APPENDIX C: EARLY COORDINATION

Sample Early Coordination Letter

Re: Early Coordination Letter
Des. No. 1700089
US 24 Intersection Improvements
Peru, Miami County, Indiana

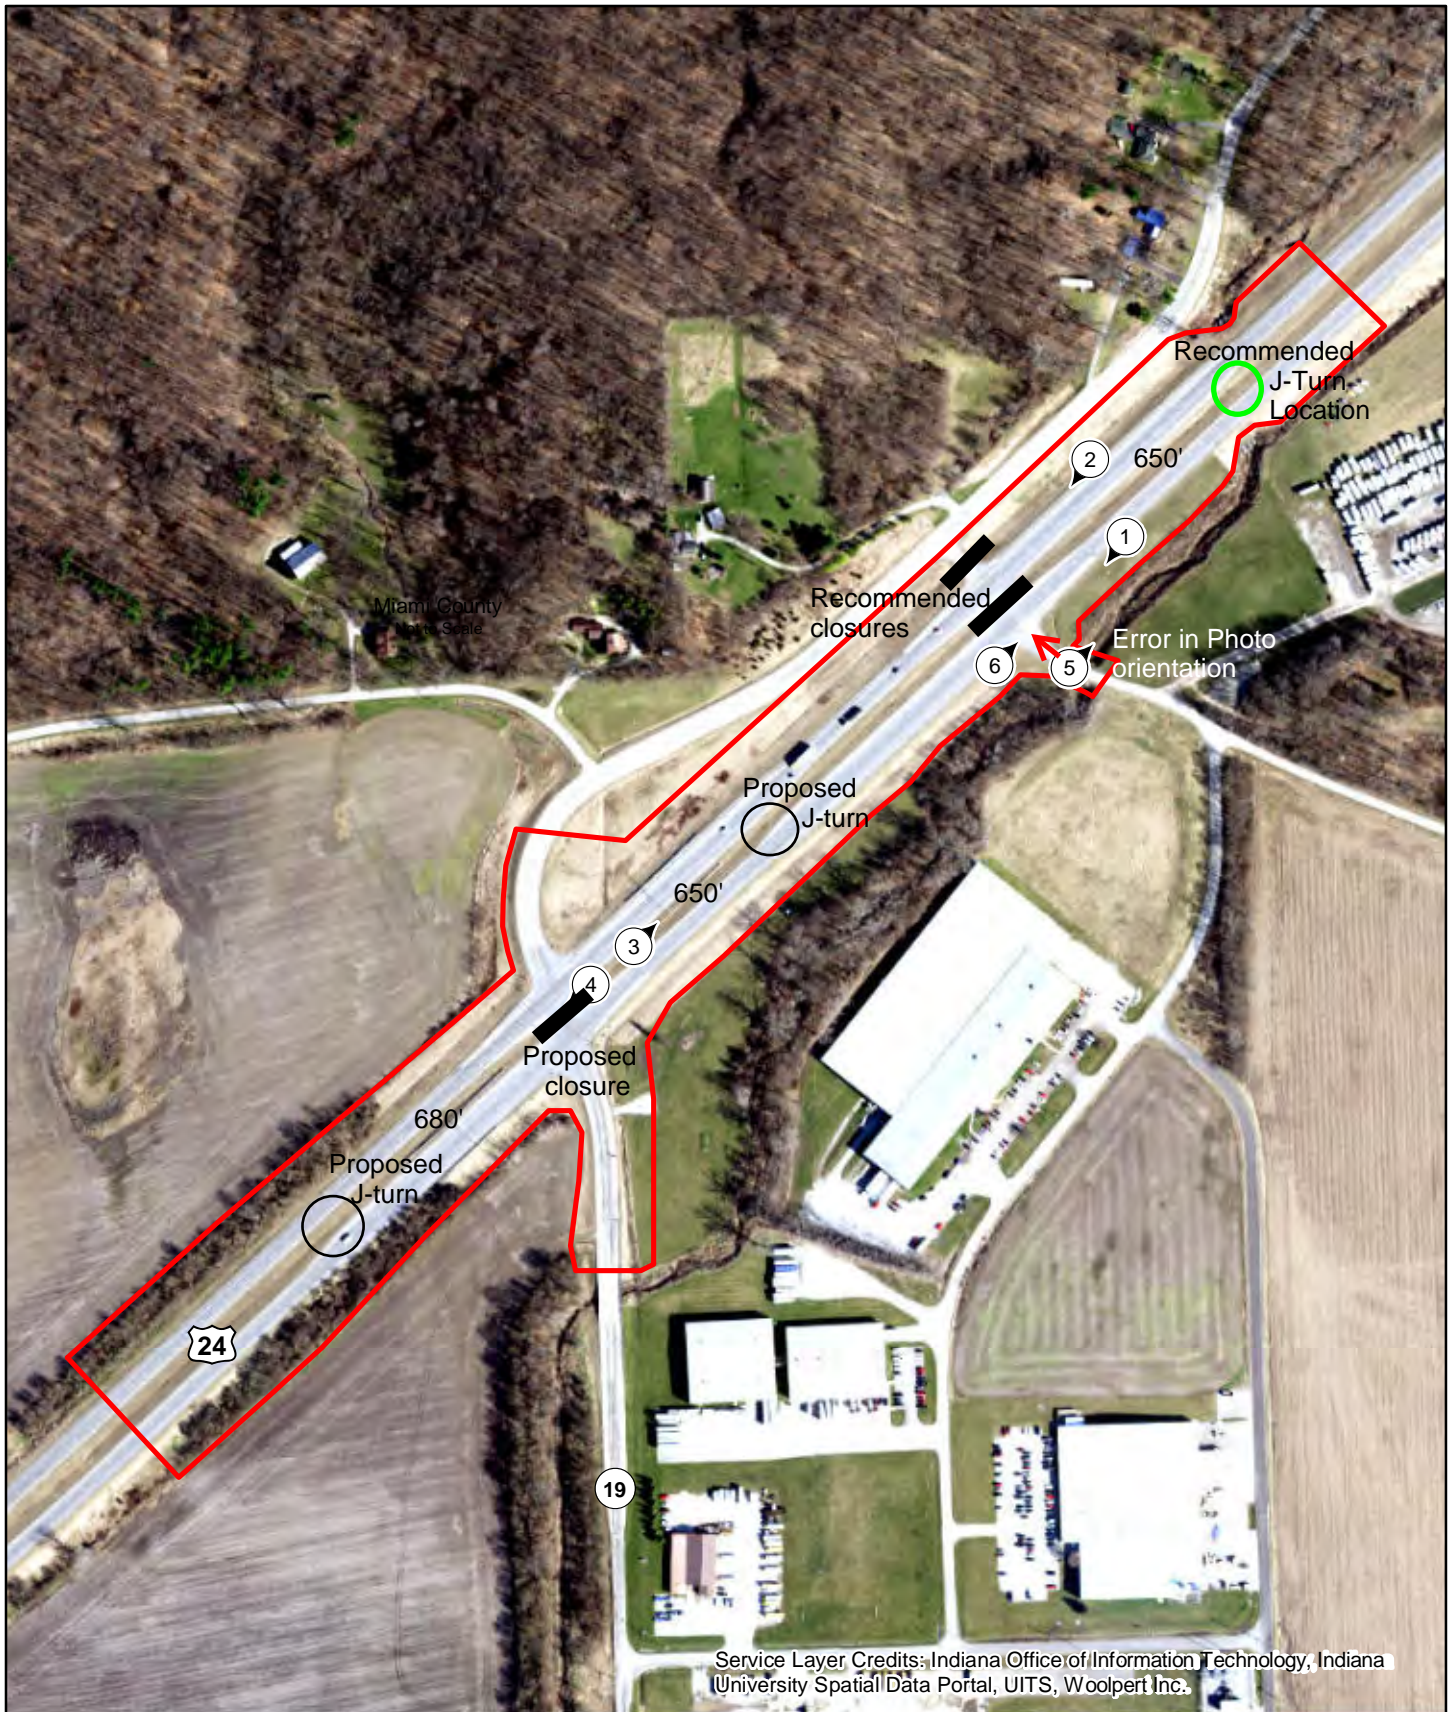
I have reviewed the attached notice and added my comments to the document. I recommend moving the northeast J-Turn to a location approximately 650 feet northeast of Lovers Lane to include the access for the commercial development in the project limits. This will provide for elimination of the crossover at the intersection of the south leg of Lovers Lane and increase the traffic safety for the traffic at the two intersections.
